Access Compliance Report

Public Rights-of-Way

Intersection ID: 4398	Main Street: AMARANTHUS_CT	Cross Street: BROOKSTONE_DR	Location: SW
ADA ID: 715DDDDC0877	Ramp Type: Perp	Initial Pass/Fail: Fail	Overall Compliance: No
Severity Score: 36.25			
Codes/Mitigation Info/Possible Solution		Field Measurements/Component Compliance

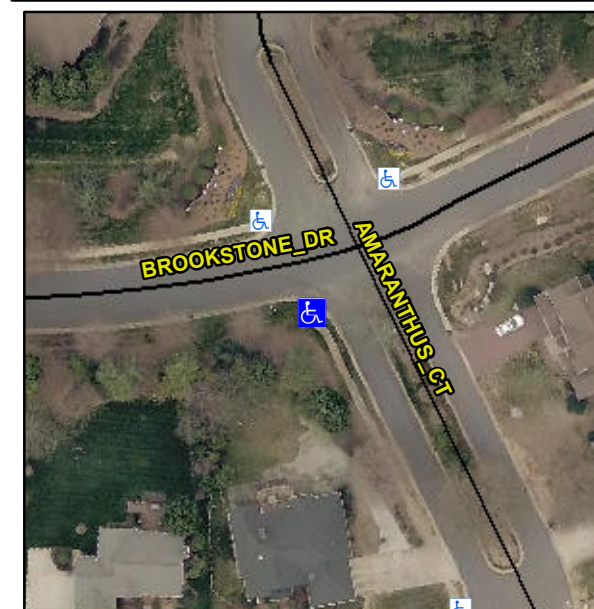
Not Found, R304.5.1, R304.5.3, R302.7

Compliance	Description	Data	Compliance	Description	Data
N/A	Ramp Length (in)	50.0	Yes	Ramp Slope (%)	6.4
No	Ramp Width (in)	37.0	No	Ramp XSlope (%)	5.7
N/A	Flare Type LT	N/A	N/A	Flare Type RT	N/A
N/A	Flare Slope LT (%)	N/A	N/A	Flare Slope RT (%)	N/A
N/A	Flare Traversable LT?	N/A	N/A	Flare Traversable RT?	N/A
N/A	Landing Length (in)	N/A	N/A	DWS Provided?	N/A
N/A	Landing Width (in)	N/A	N/A	DWS Contrast?	N/A
N/A	Landing Slope (%)	N/A	N/A	DWS Length (in)	N/A
N/A	Landing X Slope (%)	N/A	N/A	DWS Full Width?	N/A
N/A	Landing Curb? (Y/N)	N/A	N/A	DWS Offset (in)	N/A
N/A	Shared Landing?	N/A			
N/A	Gutter Ponding?	N/A	N/A	Gutter Slope (%)	N/A
N/A	Gutter Lip Ht (in)	N/A	N/A	Gutter X Slope (%)	N/A
N/A	Painted X Walk1?	No	N/A	Painted X Walk2?	N/A
	X Walk 1 Direction	To N		X Walk 2 Direction	N/A
N/A	X Walk 1 Width (in)	N/A	N/A	X Walk 2 Width (in)	N/A
	X Walk 1 Slope (%)	3.7		X Walk 2 Slope (%)	N/A
	X Walk 1 X Slope (%)	3.5		X Walk 2 X Slope (%)	N/A

N/A	Ramp inside XWalk1?	N/A	N/A	Ramp inside XWalk2?	N/A
	Road Slope (%)	N/A	N/A	Clear Space?	N/A
	Road X Slope (%)	N/A	N/A	Clear Space to XWalk (in)	N/A
N/A	Any Obstructions?	N/A	N/A	Storm Grate/Utility Hazard?	N/A
	Obstruction Type			Storm Grate/Utility Type	
		N/A			N/A
		No		Surface Condition? (G/P)	Poor

Remove & Replace Entire Ramp.
